REMARKS

The Office Action mailed July 16, 2002 has been carefully reviewed and considered. In response, a proposed drawing correction is provided, the specification has been amended and claims 1-2, 7, and 9-13 have been amended and new claims 17 and 18 have been added. Claims 1-2, 7, and 9-13 having been amended, and new claims 17 and 18 having been added, the claims now pending in the present application are claims 1-18. Favorable consideration is respectfully requested.

proposed drawing corrections have been marked in red

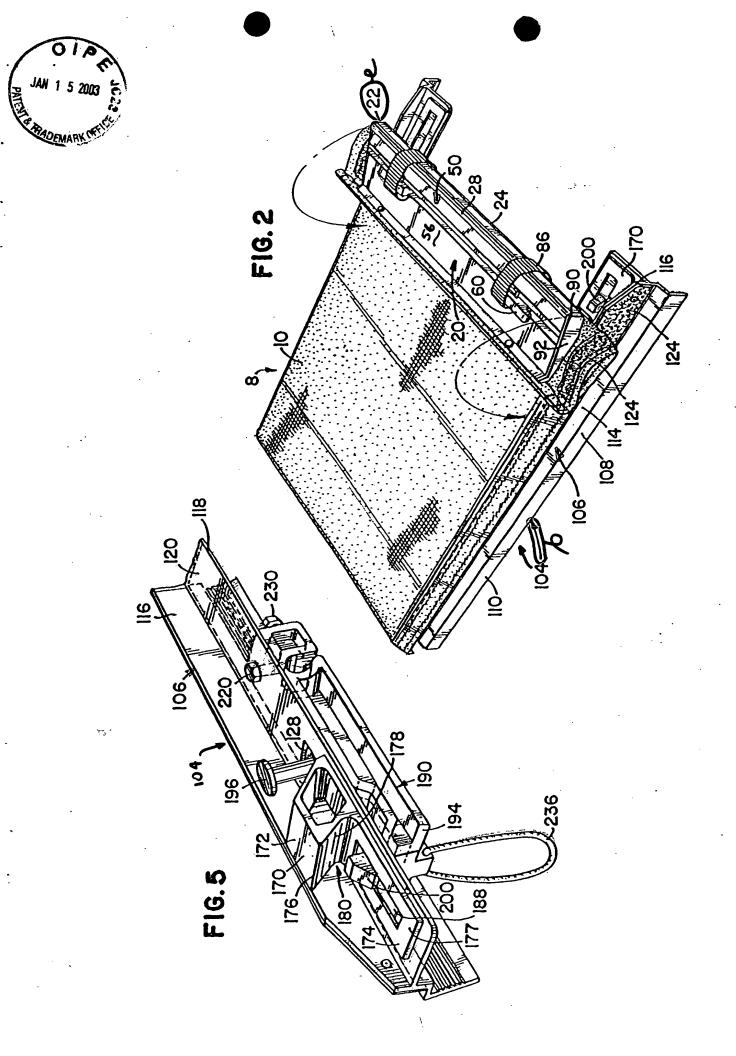
Also on page 2, in paragraph 2, the Examiner notes that Reference Numbers 50 and 56 are both used to designate a surface shown in FIGS. 3 and 10 and it is suggested that Reference Number 50 be changed to 56. The specification and drawings have been changed to clarify the elements referenced by FIGS. 50 and 56. In FIG. 3, reference Number 56 clearly references a

surface on the underside of the end plate 20. A reference has been added to the specification calling out Reference Number 56 in line 30 of page 11 and the Reference Number 56 has been added to FIG. 2 in the proposed corrected drawings and a Reference Number 50 on the underside of end plate 20 as shown in FIG. 10 has been changed in the proposed corrected drawings to 56 to accord with the prior reference to the underside of end plate 20 shown in FIG. 3. It is noted that the other use of Reference Number 50 in FIG. 10, calling out a pawl receiving area 50 of the end plate 20 finds support in the specification on page 13, line 11. A further reference to an upper surface 33 is added to the specification on page 11, line 30 and the Reference Number has been added to the proposed corrected drawings in FIG. 3 where the Reference Number 33 calls out an upper surface 33 of the end plate 20 which is shown in phantom. A further reference is added to the specification on page 11, line 30 to a trailing surface 34 which is shown in FIG. 3 and FIG. 7. The lead line for the trailing surface 34, shown in phantom in FIG. 3, has been amended to clearly indicate that the Reference Number 34 is calling out the trailing surface of the end plate 34 as shown in FIG. 7 and referenced in the amended portion of the specification discussed above.

In subparagraph b of paragraph 4, reference is made to Reference Number 56 in FIGS. 3 and 10. The drawings have been amended to add Reference Number 56 in FIG. 2, consistent

FIG. 7

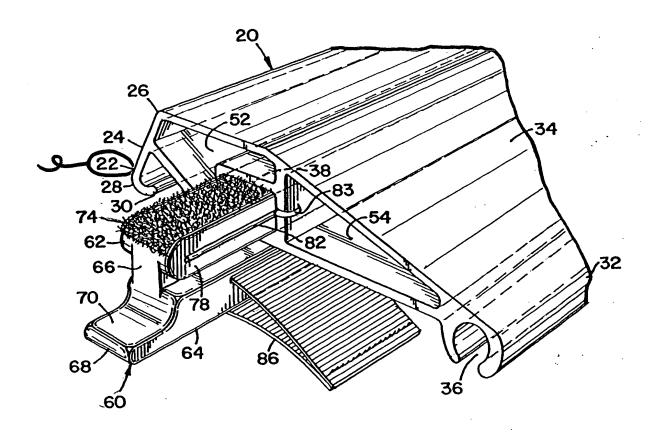
In subparagraph d of paragraph 4, the use of Reference Number 34 in FIG. 7 is objected to. In response, the specification has been amended at the end of the second full paragraph on page 11 which begins at line 21, to include a reference to a trailing surface 34 which is also referenced in FIG. 3.

FIG. 11

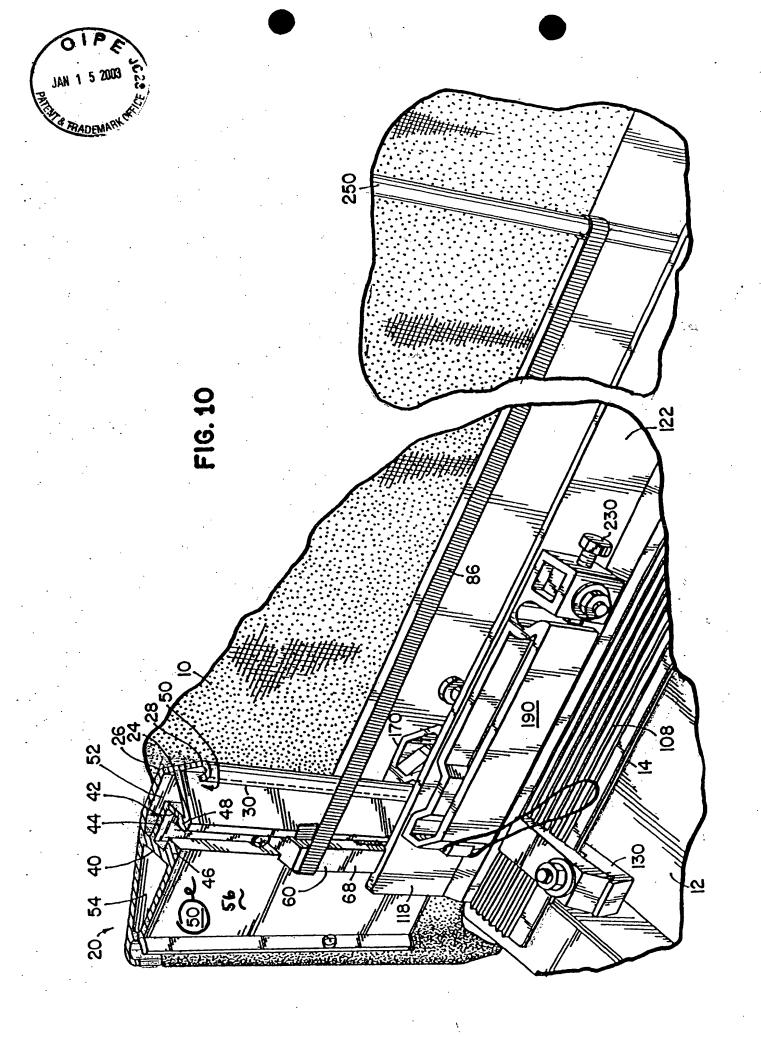
In subparagraph f of paragraph 4, it is noted that there is no reference to Reference Numbers 430 in the specification. The specification has been amended on page 20, in the paragraph which begins on line 23, to include a reference to a side panel 430 which is shown in FIG. 11, as well as to a flexible cover 410 which is also shown in FIG. 11.

FIG. 14

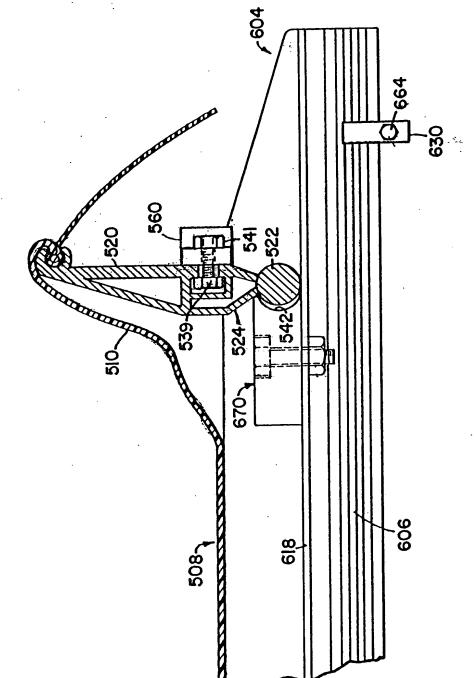
In subparagraph g of paragraph 4, it is noted that there is no reference to Reference Numbers 508, 536, 604, 630 and 664 in the specification; however, each of these Reference Numbers appear in FIGS. 13-15. In response, the specification has been amended to include references to each of these Reference Numbers. Support for the amendments to the specification is provided in FIGS. 1-10 which call out equivalent elements in the preferred embodiment disclosed in those FIGS. and also in the statement on page 22, lines 6-8 which, in reference to the alternate embodiment shown in FIGS. 13, 14 and 15, indicates that "The other features of this

In order to provide appropriate reference to these Reference Numbers, further description which finds support in FIGS. 13-15 and the aforementioned description of the preferred embodiment, has been added to the specification on page 22 at the end of the carryover paragraph.
